APPLICATION NO.	FILING DATE	FIRST NAMED INVENTOR	ATTORNEY DOCKET NO.	CONFIRMATION NO.
10/580,307	05/24/2006	Miguel Sarabia Trilla	4826-P04074US00	4168
	7590	EXAMINER		
1601 MARKET STREET			NGUYEN, HUNG D	
SUITE 2400 PHILADELPHIA, PA 19103-2307			ART UNIT	PAPER NUMBER
			3742	
			MAIL DATE	DELIVERY MODE
			06/23/2010	PAPER

Office Action Summary		Application No.	Applicant(s)	Applicant(s)			
		10/580,307	SARABIA TRILLA	SARABIA TRILLA, MIGUEL			
		Examiner	Art Unit				
		HUNG NGUYEN	3742				
Period fo	The MAILING DATE of this communication or Reply	appears on the cover s	heet with the correspondence a	ddress			
WHIC - Exter after - If NO - Failu Any r	ORTENED STATUTORY PERIOD FOR RESERVER IS LONGER, FROM THE MAILING asions of time may be available under the provisions of 37 CFR SIX (6) MONTHS from the mailing date of this communication. Period for reply is specified above, the maximum statutory per re to reply within the set or extended period for reply will, by state ply received by the Office later than three months after the management of the provided patent term adjustment. See 37 CFR 1.704(b).	B DATE OF THIS COM R 1.136(a). In no event, however iod will apply and will expire SIX

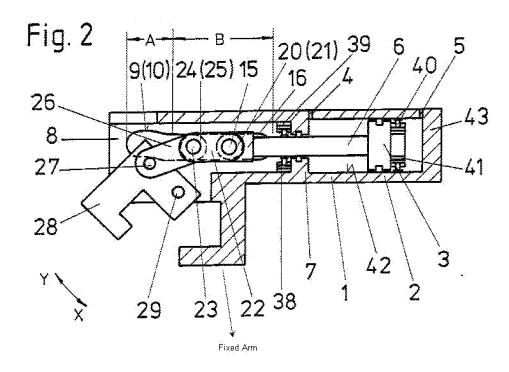
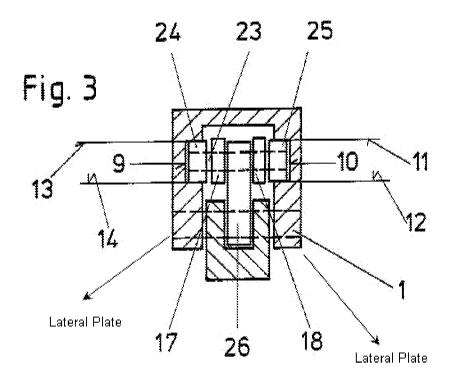
- 8. Regarding claim 1, Tunkers'3944 discloses a clamp for automated welding installations, for holding two or more sheets 30 (Fig. 1) to be handled during welding, said clamp comprising: a body 1 (Fig. 2 below), a fixed arm (Fig. 2 below) and a mobile arm 28 (Fig. 1 below) adapted to hold said two or more sheets, a pneumatic cylinder 2 (Fig. 2 below) for activating said mobile arm of the clamp, said body being in the form of a central tubular element (Fig. 2 below) surrounding said pneumatic cylinder 2 (Fig. 2 below) and having two opposing lateral plates (Fig. 3 below) welded to one end thereof, said mobile arm 28 (Fig. 2 below) being mounted for pivotal movement by said plates at the center of the clamp between said lateral plates (Fig. 3 below).

- 10. Regarding claim 8, Tunkers'3944 discloses said pneumatic cylinder 2 (Fig. 2 below) has upper 43 (Fig. 2 below) and lower 7 (Fig. 2 below) fixed covers, a cylindrical casing (Fig. 2 below) joined to these upper and lower covers to seal the cylinder, said casing being slightly spaced from the internal side of said tubular element to provide a spacing providing a passage for air connecting the upper with the lower parts of the cylinder (Fig. 2), said pneumatic cylinder having a piston 3 (Fig. 2 below) and a piston rod 6 (Fig. 2 below) having an extension for activating said mobile arm 28 (Fig. 2 below).

- 11. Regarding claim 11, Tunkers'3944 further discloses an orifice 5 (Fig. 2 below) in said upper cover 43 (Fig. 2 below) admitting air into said spacing between the cylinder casing and the tubular element of the body 1 (Fig. 2 below).

- 12. Regarding claim 19, Tunkers'3944 further discloses a clamp for automated welding installations comprising a body 1 (Fig. 2 below) and at least two arms 28 (Fig. 2 below) adapted to be used to hold two or more sheets 30 (Fig. 1) to be handled during welding, at least one of said arms 28 (Fig. 2 below) being mobile and mounted for pivotal movement, and a pneumatic cylinder 2 (Fig. 2 below) for activating said at least one mobile arm 28 (Fig. 2 below), wherein said body has a central tubular element with two opposing lateral plates (Fig. 3 below) at the lower part thereof, and a fixed pivot shaft 29 (Fig. 2 below) supported by said plates to support said at least one mobile arm

for said pivotal movement, said mobile arm being disposed at the center of the clamp between the lateral plates (Refer to Fig. 3 below), said central tubular element housing said pneumatic cylinder 2 (Fig. 2 below) having a piston 3 (Fig. 2 below), a piston rod 6 (Fig. 2 below), and an extension at its free end with an activation roller 15/23 (Fig. 3 below) engaging a said mobile arm and operable to effect pivotal movement of said mobile arm on said fixed pivot shaft 29 (Fig. 2 below).

- 19. Regarding claim 5, Tunkers'3944 discloses a fixed transverse pivot shaft 29 (Fig. 2 below) mounted between said opposing lateral plates (Fig. 3 below), and an activation roller 15/23 (Fig. 2 below) operable to be displaced by said mobile arm 28 (Fig. 2 below) of the clamp on said shaft. Tunkers'3519 discloses said opposing lateral plates of the body of the clamp 7 (Fig. 3) and 8 (Fig. 4) have lightening openings, orifices for mounting the ends of the pivots shaft of the mobile arm of the clamp and elongate holes 18 (Fig. 3) and 19 (Fig. 4) for guiding said activation roller for displacing the mobile arm 6 (Fig. 1) of the clamp.

- 21. Regarding claim 6, Tunkers'3944 discloses wherein said body has a pneumatic cylinder 2 (Fig. 2 below) for activating the clamp, a piston rod 6 (Fig. 2 below) with a drive rod at its free end and an activation roller 15/23 (Fig. 2 below) on said drive rod for pivoting said mobile arm 28 (Fig. 2 below), and wherein said mobile arm of the clamp is

mounted for pivoting on a fixed pivot shaft 29 (Fig. 2 below) between said plates, and takes an L-shaped position (Fig. 2 below); said mobile arm 28 (Fig. 2 below) being disposed between said opposing lateral plates (Fig. 3 below) except the mobile arm presents on its internal end an elongated hole that causes the arm to pivot on said pivot shaft, said mobile arm being disposed between said opposing lateral plates, said elongated hole adapted to receive said activation roller, said elongated hole of the arm having a straight inferior area and a gently curved upper area to cause the progressive variation of the angle of incidence between the transverse shaft pivoting the mobile arm and the elongated hole of said mobile arm, and whereby the straight area provides an irreversibility area on triggering. Sawada et al. discloses the mobile arm 23 (Fig. 2) presents on its internal end an elongated hole 25 (Fig. 2) that causes the arm to pivot on said pivot shaft 28 (Fig. 2), said elongated hole 25 (Fig. 2) adapted to receive said activation roller 24 (Fig. 2), said elongated hole of the arm having a straight inferior area 25a (Fig. 2) and a gently curved upper area 25b (Fig. 2) to cause the progressive variation of the angle of incidence between the transverse shaft 28 (Fig. 2) pivoting the mobile arm and the elongated hole 25 (Fig. 2) of said mobile arm, and whereby the straight area provides an irreversibility area on triggering. It would have been obvious to one of ordinary skill in the art at the time of the invention was made to utilize in Tunkers'3944, the mobile arm presents on its internal end an elongated hole that causes the arm to pivot on said pivot shaft, said elongated hole adapted to receive said activation roller, said elongated hole of the arm having a straight inferior area and a gently curved upper area to cause the progressive variation of the angle of incidence
